RE: Florida Power & Light Company
Turkey Point Unit 4
Docket No. 50-251

Subject: Response to NRC Request for Additional Information Regarding the Responses to GL 2004-02, "Potential Impact of Debris Blockage on Emergency Recirculation During Design Basis Accidents at Pressurized-Water Reactors," TAC NO. MC4726

ATTACHMENT 1
Responses to NRC's Request for Additional Information on
FPL's Turkey Point Nuclear Plant Unit 4 (PTN4)
GL 2004-02 Response Dated February 28, 2008
and Supplemental Response dated August 11, 2008

Figure 2-1 Break S2 and Shadow Area

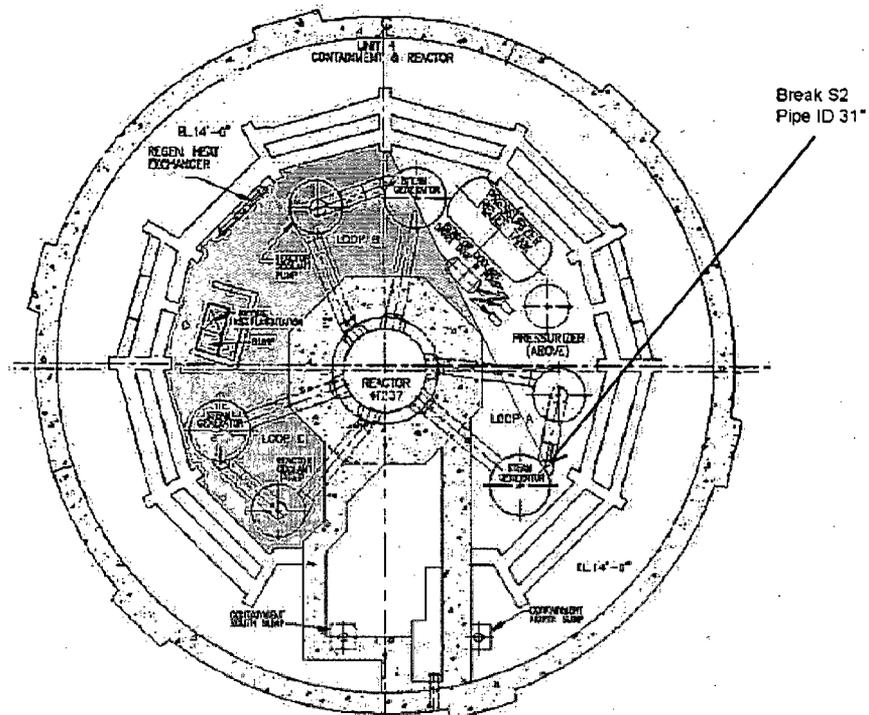
Please provide your evaluation that establishes that breaks at or near the reactor nozzle will not result in a more limiting debris generation condition than the breaks presented in the supplemental response. Please describe the insulating material(s) for the reactor vessel.

From these break location considerations, the limiting break that resulted in the bounding debris generation was S2. See Figure 2-1, below.

Table 5-1 Approach Velocity

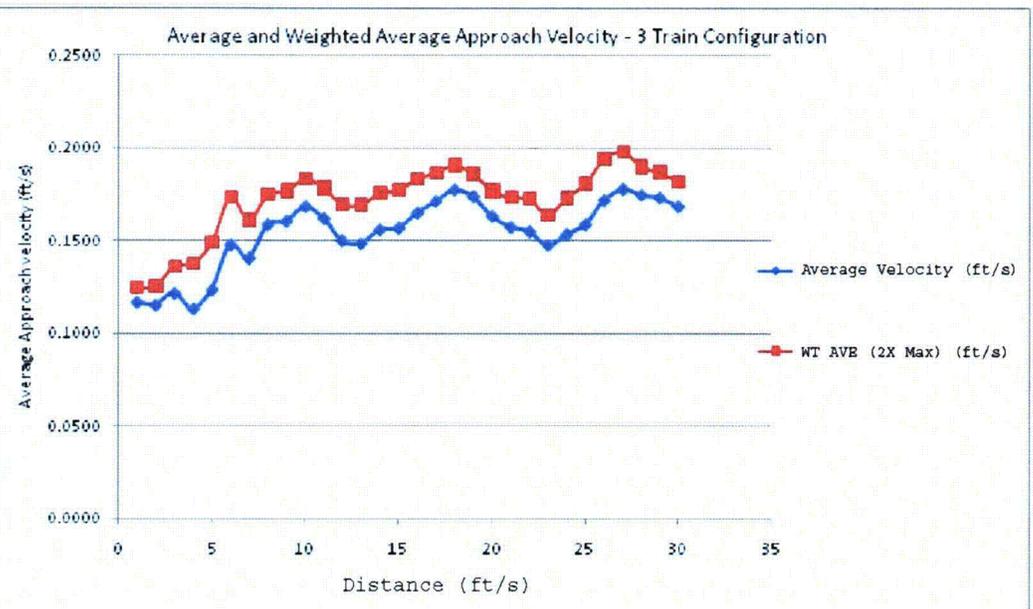
Please provide a contour plot of the containment pool velocities that includes both the velocities inside the bioshield wall and in the outer annulus. Please also provide a close-up plot of the velocity and turbulence contours in the region of the strainer and its immediate surroundings. Please also provide a table of the head loss test flume (average) velocity as a function of distance from the test strainer and identify the turbulence level simulated in the test flume.

Figure 7-1 Plot of turbulent kinetic energy within 20 feet of the strainer

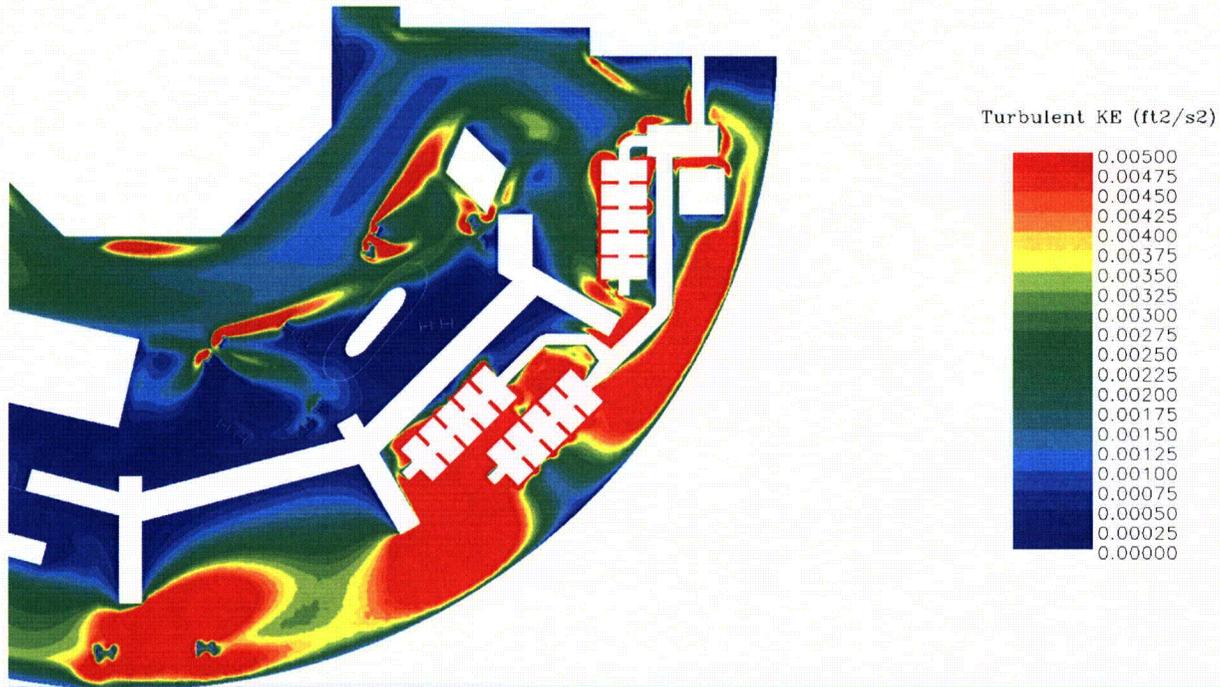
Please describe how the kinetic energy of the containment sprays entering the containment pool was modeled. Spray flow splashing into the containment pool can have a significant impact on the velocity and turbulence distributions in the containment pool. Furthermore, the drainage from the containment sprays frequently is not uniform (as is assumed for Turkey Point 4) at the containment pool elevation due to non-uniformities in the structures at higher elevations that can result in concentrated drainage (e.g., refueling canal drains, hatch openings, gaps in curbs, etc.). Please provide the justification for using a uniform spray drainage model.

Turbulent kinetic energy was specified at the water surface where the water from the sprays is assumed to enter the pool. To set a turbulence level at this inflow location, the turbulence intensity was set to 5% and the turbulent viscosity ratio was set to 5%. A kinetic energy plot is shown in Figure 7-1 below.

Figure 8-1 Isocontours of Velocity: 6 fps and above

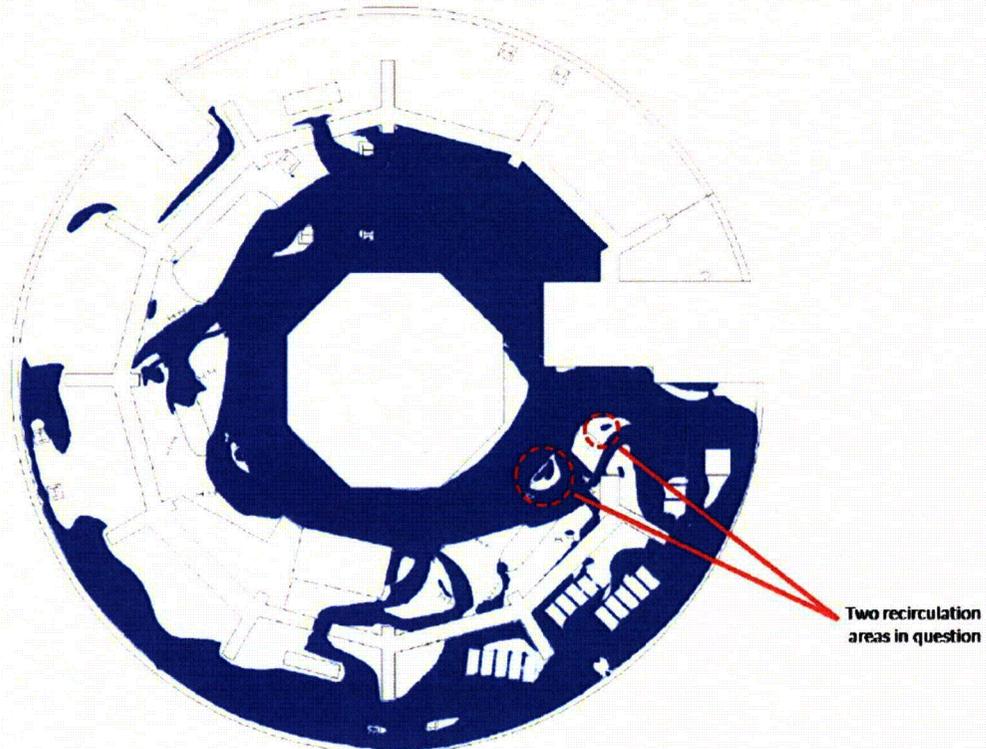
The August 11, 2008, supplemental response states on page 16 that streamline plots were used to identify isolated eddies that had velocities higher than the incipient tumbling velocity but did not contribute to debris transport from the zone. Please provide the basis for considering debris assumed to be present in this area at the switchover to recirculation to not transport to the strainers, considering the following points:

The areas of recirculation in question only exist for the 0.06 ft/s velocity contours (associated with transport of small fiberglass material) and are identified in Figure 8-1 below. The areas

within the recirculation zones represent 0.12% of the total area that transports material to the screens. The material contained in this zone is considered negligible compared to the total amount of material transported to the sump screens.

Figure 11-1 Turkey Point Unit 4 Debris Interceptor System

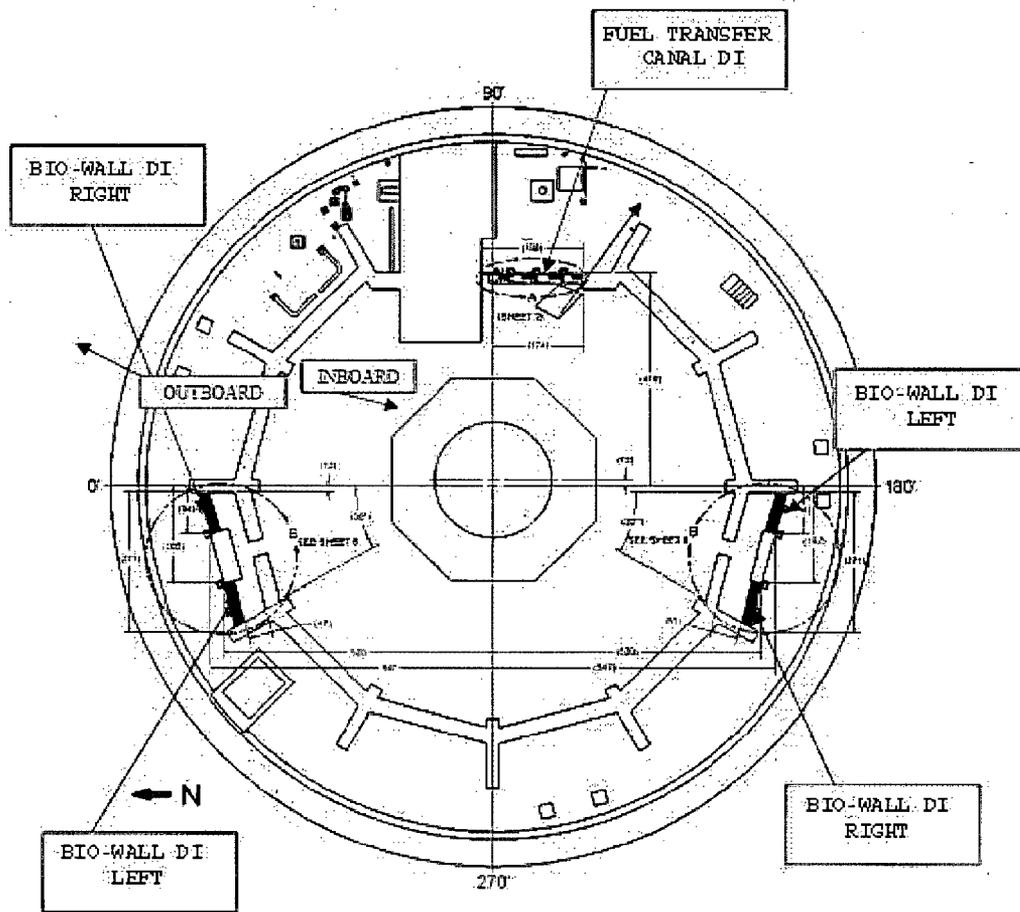
The supplemental response did not provide sufficient information concerning the debris interceptors to justify the credit apparently assumed for fibrous debris capture at the interceptors. Please provide the following information concerning the debris interceptors:

The dimensions of the roof of the test debris interceptor were 25" x 19". The roof area is 475 square inches. The installed debris interceptors are of various lengths between approximately 35 inches and 50 inches with a nominal width of approximately 19 inches. The installed debris interceptors (DIs) are designated as Bio-Wall Left, Bio-Wall-Right, and Fuel Transfer Canal. The total installed DI roof area is approximately 9000 square inches (see Figure 11-1 below).

Figure 15-2 Test Flume Configuration

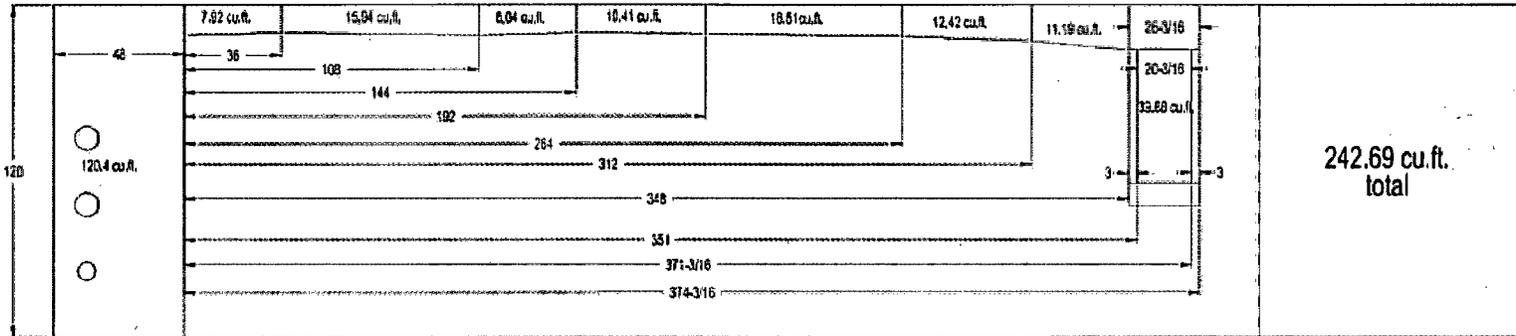
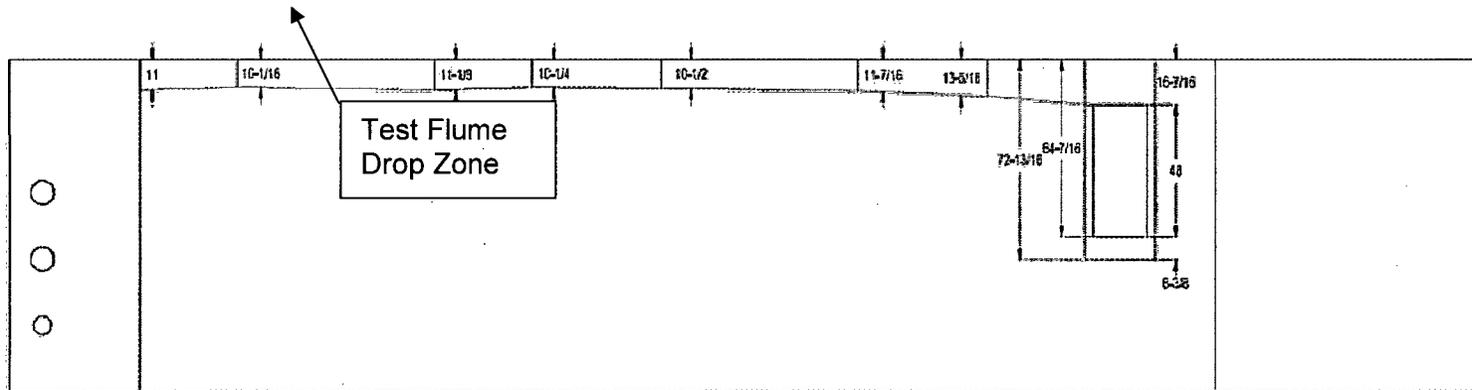
Please include: Debris introduction locations in the test flume, and the amount of each debris surrogate added to each test.

All debris types with the exception of the first batch (25% of the latent fiber) were introduced into the test flume at the drop zone. Figure 15-2, below, provides the flume wall configuration, with the drop zone for non-chemical and chemical debris labeled. From Figure 15-2, the drop zone is ~350 inches upstream of the strainer module. Batch 1 (25% latent fiber) was introduced uniformly throughout the length of the test flume. The debris amounts that were weighed and introduced into the test flume are presented in Table 15-1 below.

Figure 16-1 Plot of Measured Head Loss versus Time for Design Basis Test.

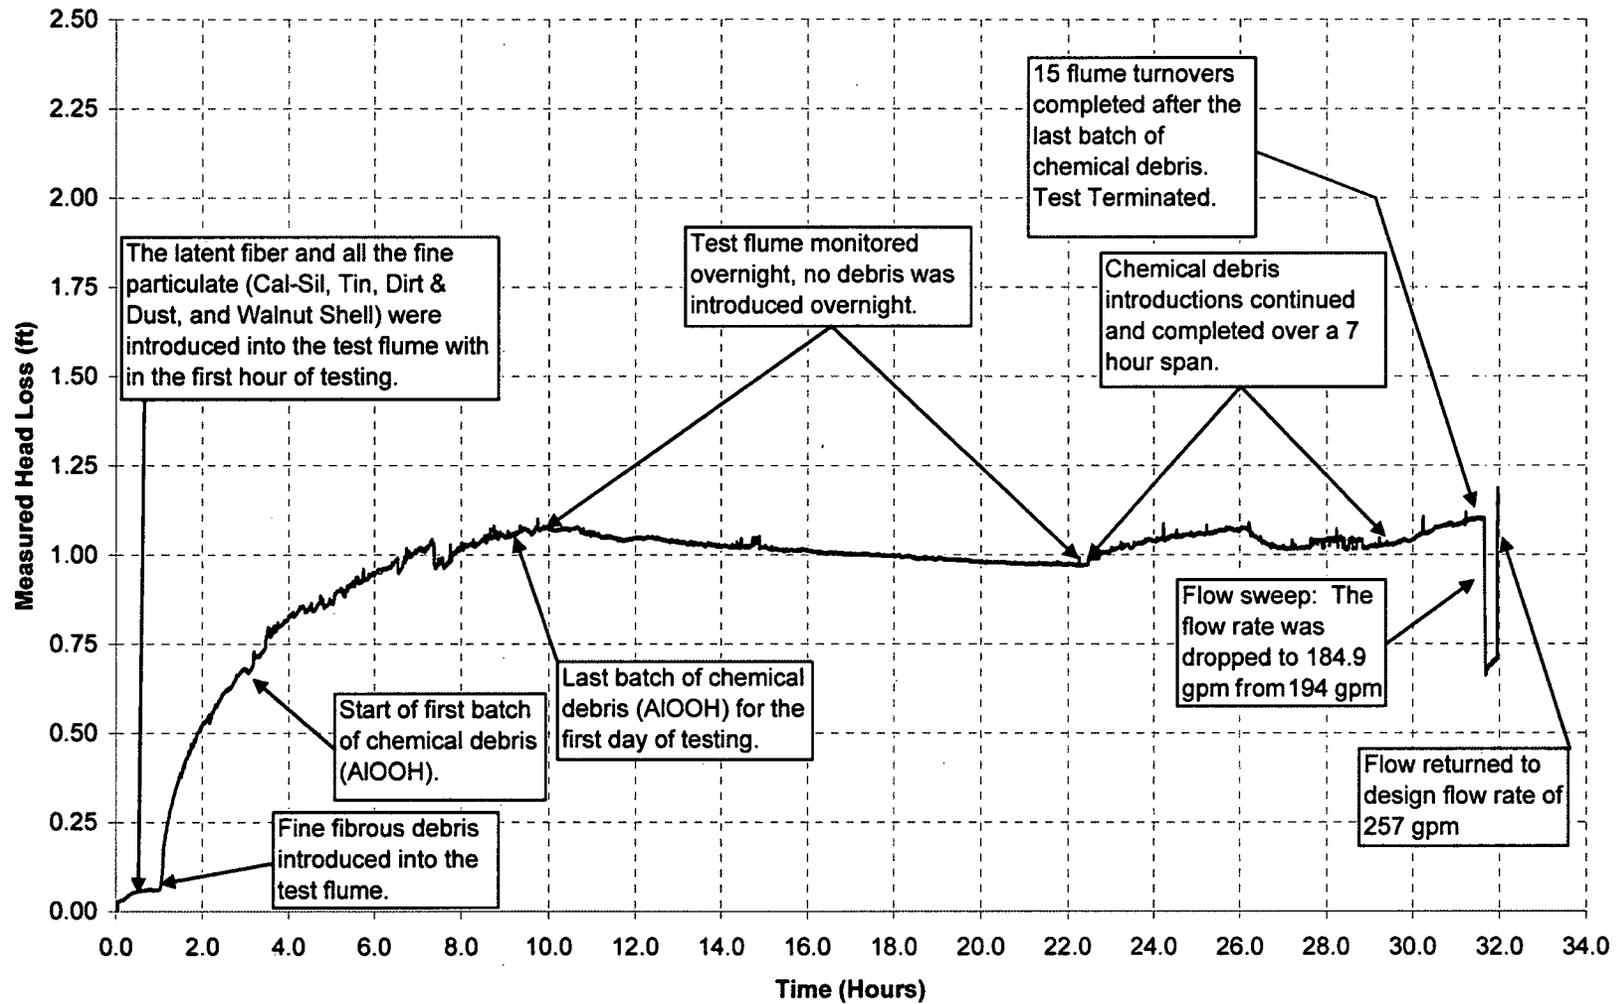
Please provide a graph of head loss versus time for the duration of the chemical effects testing, including the initial nonchemical portions. Include information regarding events that would be expected to affect the head loss such as debris addition, large flow changes, flow sweeps, etc.

Figure 16-1 below displays a plot of the measured head loss (ft) versus time (hours) for the PTN4 Design Basis Test.

Figure 18-2 Zoomed Picture of the Test Strainer during Drain Down

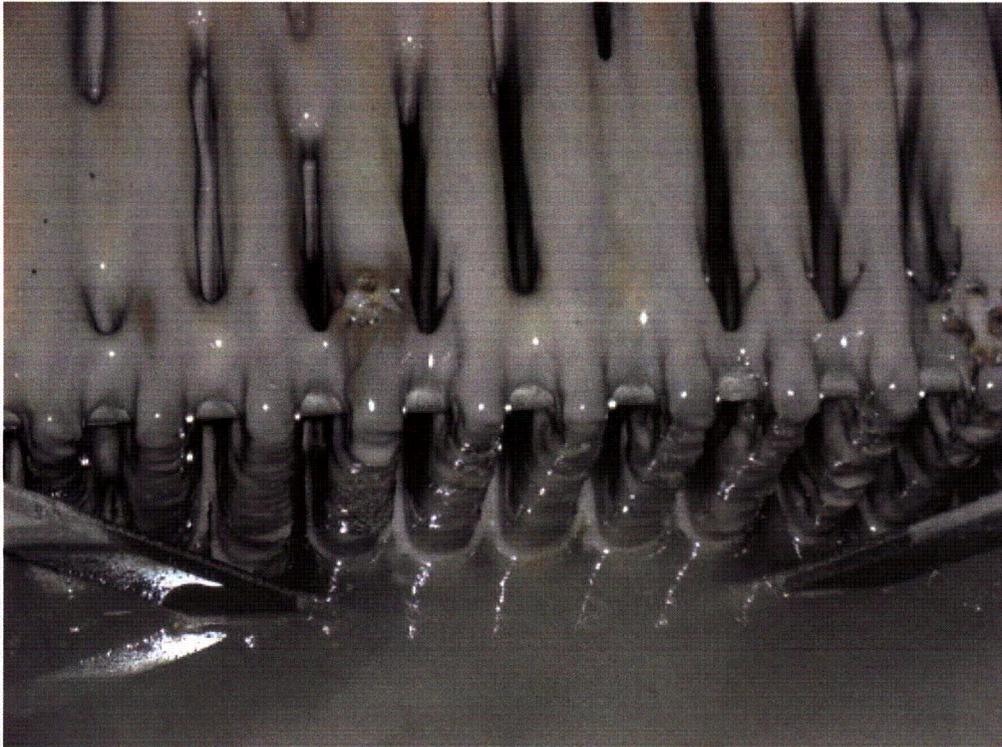
The supplemental response stated that the head loss determined by testing was extrapolated to higher temperatures expected during recirculation. The supplemental response indicated that a fiber-only test resulted in significant clean strainer area. It was not stated whether there were clean strainer areas following testing with chemicals and particulates. Clean strainer can result in turbulent flow which complicates attempts to viscosity correct head loss results to higher temperatures. It was not stated whether bore holes or other pressure driven phenomena occurred during testing. Flow sweeps should have been conducted to assure that a temperature extrapolation of head loss test data was valid. State the assumptions and their bases for the temperature extrapolation evaluation. Please state whether there was clean strainer area following the limiting chemical effects test. State whether there were bore holes or similar phenomena that occurred during testing.

After drain down, the strainer had a bed of chemical debris covering the entire surface of the strainer, and there appeared to be no evidence of open strainer surface area. Thus, there were no clean strainer areas on the test strainer module, which can be seen in the pictures taken during test flume drain down. Figure 18-1 provides a picture at the start of test flume drain down with debris settled on top of the strainer module. Figure 18-2 shows a zoomed view of the top and front edge of the strainer module during drain down.
